#2010-27

Park Place Final PUD Amendment

Project Review for Planning and Zoning Commission

<u>Meeting Date:</u>	July 21, 2010
<u>Request:</u>	Final PUD Amendment to allow the extension of decks and patios to extend beyond the previously approved limits, which would require variations to allow encroachment into the rear yard setback and to the maximum permitted impervious coverage.
<u>Location:</u>	West of Randall Road at Alexandra Boulevard
<u>Acreage:</u>	Approximately 26 acres
<u>Zoning:</u>	R-3B PUD Multi-Family
<u>Surrounding Properties:</u>	North: R-2 PUD Single Family (Crystal in the Park Unit 1) South: R-1 PUD Single Family (The Villages) East: R-3B PUD Multi-Family (Phase 1 of Park Place) and R-2 PUD (detention) West: R-2 PUD Single Family (Crystal in the Park Unit 2)
<u>Staff Contact:</u>	Elizabeth Maxwell (815.356.3615)

option #2: units w/ no basements or well (full underground)

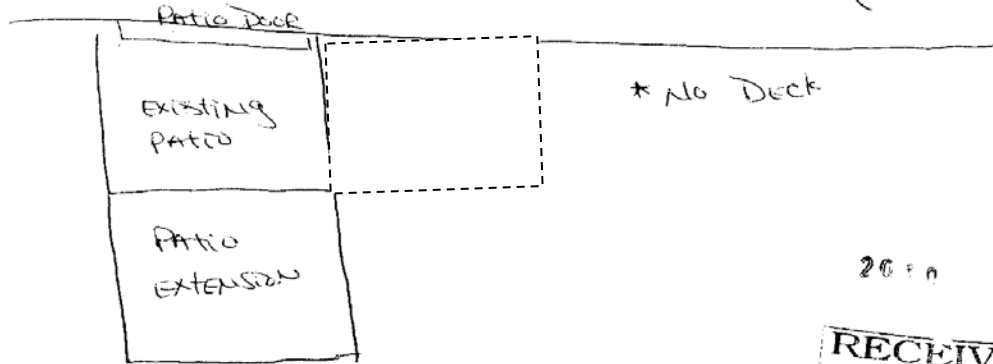
Homes that only have a patio may only construct a patio extension and cannot construct a deck. The existing patios vary but are approximately 8' x 8'. The patio extension would extend 6' farther into the rear yard and maintain their 8' width. See the below illustration.

The guideline criteria also allows for the use of stamped concrete or other treatment to the concrete. If this is used, the entire patio area must have the same decorative treatment. The criteria also require the homeowner to be responsible for onsite grading and relocation of any landscape materials. Instead of coming straight out from the existing patio, the patio slab extension could be out to the side of the existing patio.

option #1: units w/ walk out or look out basements

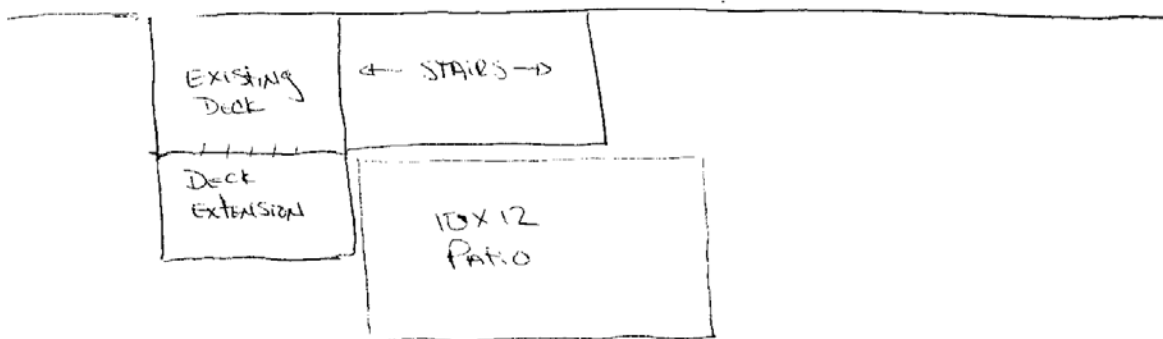
The townhome units with decks would be permitted a deck and patio area. Existing decks are approximately 4' out from the house and 7' wide. The proposed deck extension would allow an additional 6.5' into the rear yard and 7' wide. The patio is required to start near the foot of the stairs and can be a 10' x 12' patio slab. The illustration below shows the proposed layout.

Deck extensions need to match the color and materials of the existing deck. The homeowner is also responsible for onsite grading and relocation of landscape materials. Since the proposed patio slab is not attached to the principle structure or connected to the deck to provide access between the two, it is considered a detached accessory structure and can be 5 feet from any property line. If however, the homeowner wraps the patio slab around and connects it to the stair footing it will become one attached accessory structure and be subject to the setback requirements.
